STAFF REPORT

RZ 2015-MA-018

APPLICANT: Fairfax County Board of Supervisors (Jefferson Fire Station #18)

PROPOSAL: Rezone the site from C-5 to R-4 to replace the existing fire station and increase the maximum building area, up to a maximum of 18,300 square feet. (0.34 FAR)

SHEET TITLE:
TREE PRESERVATION

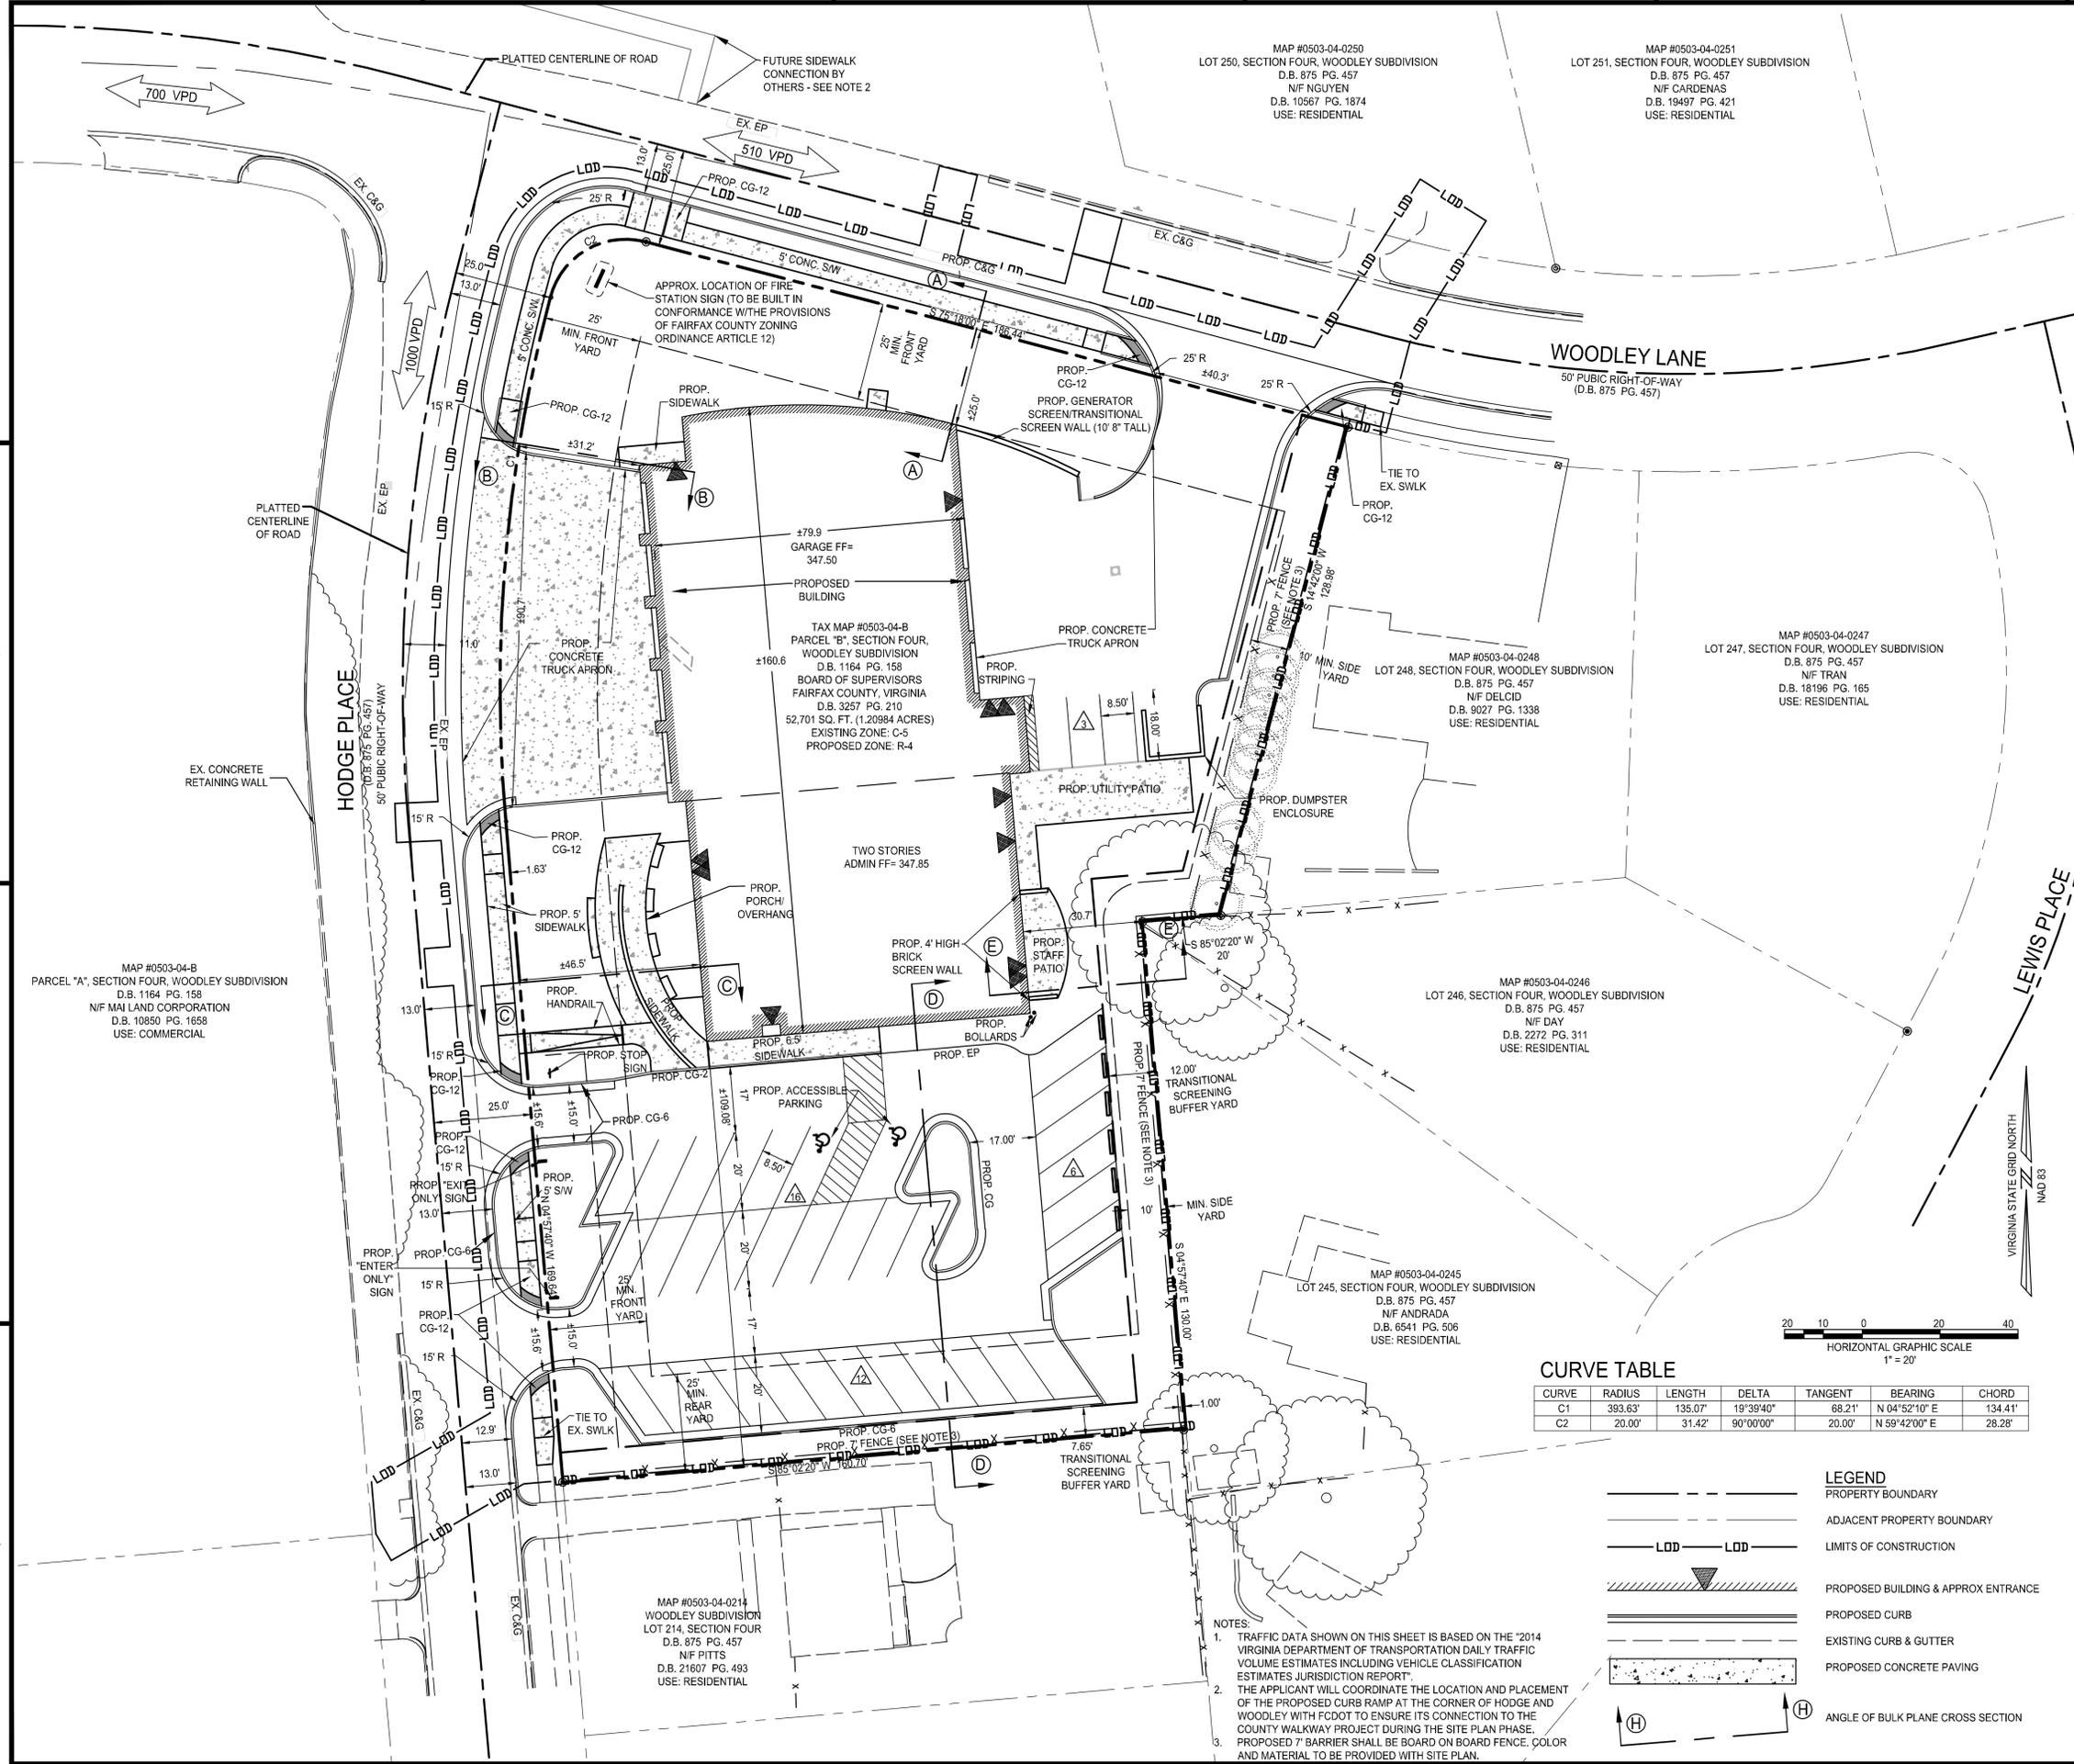
UFMD staff recommended that the applicant redesign the site to maximize the preservation of the existing row of red cedars along with the offsite tree #314. As such, the applicant has included the existing red cedars in the Tree Preservation plan. Staff also recommended that the applicant create denser transitional screening in the front of the building, along Hodge Place. However, due to sight distance limits the applicant is unable to provide additional recommended screening in that location.

In response to staff comments, the applicant has revised the GDP to include the preservation of the red cedar trees on the eastern property boundary line. On the northern property line adjacent to Woodley Lane, the applicants have incorporated Category II and IV deciduous trees to help create a denser landscape along the northern portion of the building. The applicant has also revised the GDP to include Category II and IV evergreen trees along the southern property boundary. Staff believes these concerns have been adequately addressed.

NORTHEAST TRANSITIONAL SCREENING

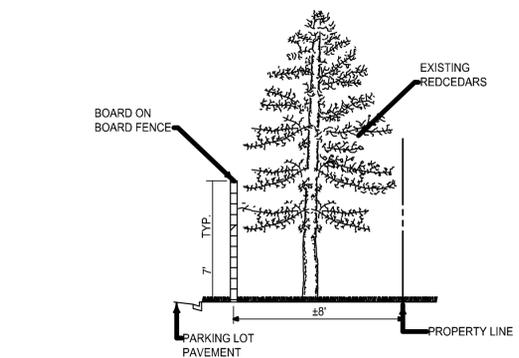
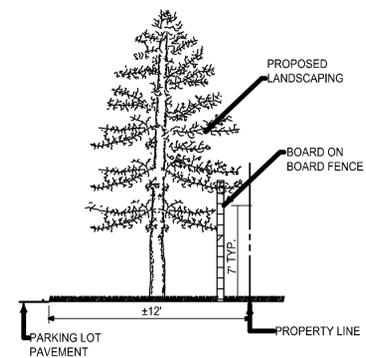
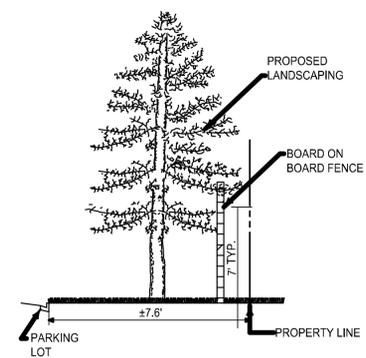
Due to the reduction of transitional screening along the southern and eastern property boundaries, UFMD staff recommended that the applicant plant Category II evergreen trees along the property boundaries to form a denser screen. The applicant has since revised the GDP to reflect these Category II evergreen trees along the eastern and southern property boundaries.

because of the compact nature of the site. However, staff recommends that the applicant utilize a board on board fence to provide the benefits of a masonry wall while allowing larger shade trees and vegetation to establish the larger root zone needed to flourish, as well as to minimize the impacts to existing off-site trees.

Staff recommends approval of a modification of transitional screening requirements on the north, east and south property boundaries, in favor of that depicted on the GDP.

Staff recommends the approval of a modification of barrier requirements, to permit a 7 foot tall board on board fence to serve as the barrier wall as depicted on the GDP.
